Access Compliance Report

Public Rights-of-Way

Intersection ID: 10020967	Main Street: BENSEVAL_LN	Cross Street: N/A	Location: W
ADA ID: FD56BEDA15E2	Ramp Type: Perp	Initial Pass/Fail: Fail	Overall Compliance: No
			Severity Score: 10

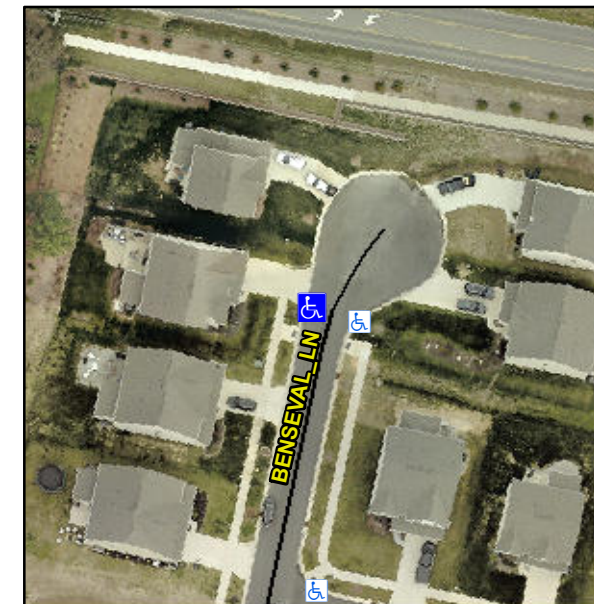
Compliance	Description	Data	Compliance	Description	Data
N/A	Ramp Length (in)	96.0	Yes	Ramp Slope (%)	6.2
No	Ramp Width (in)	47.5	Yes	Ramp XSlope (%)	2.7
N/A	Flare Type LT	N/A	N/A	Flare Type RT	N/A
N/A	Flare Slope LT (%)	N/A	N/A	Flare Slope RT (%)	N/A
N/A	Flare Traversable LT?	N/A	N/A	Flare Traversable RT?	N/A
N/A	Landing Length (in)	N/A	N/A	DWS Provided?	N/A
N/A	Landing Width (in)	N/A	N/A	DWS Contrast?	N/A
N/A	Landing Slope (%)	N/A	N/A	DWS Length (in)	N/A
N/A	Landing X Slope (%)	N/A	N/A	DWS Full Width?	N/A
N/A	Landing Curb? (Y/N)	N/A	N/A	DWS Offset (in)	N/A
N/A	Shared Landing?	N/A			
N/A	Gutter Ponding?	N/A	N/A	Gutter Slope (%)	N/A
N/A	Gutter Lip Ht (in)	N/A	N/A	Gutter X Slope (%)	N/A
N/A	Painted X Walk1?	No	N/A	Painted X Walk2?	N/A
	X Walk 1 Direction	To E		X Walk 2 Direction	N/A
N/A	X Walk 1 Width (in)	N/A	N/A	X Walk 2 Width (in)	N/A
	X Walk 1 Slope (%)	4.6		X Walk 2 Slope (%)	N/A
	X Walk 1 X Slope (%)	3.4		X Walk 2 X Slope (%)	N/A

Remove & Replace Entire Ramp.

R304.5.1
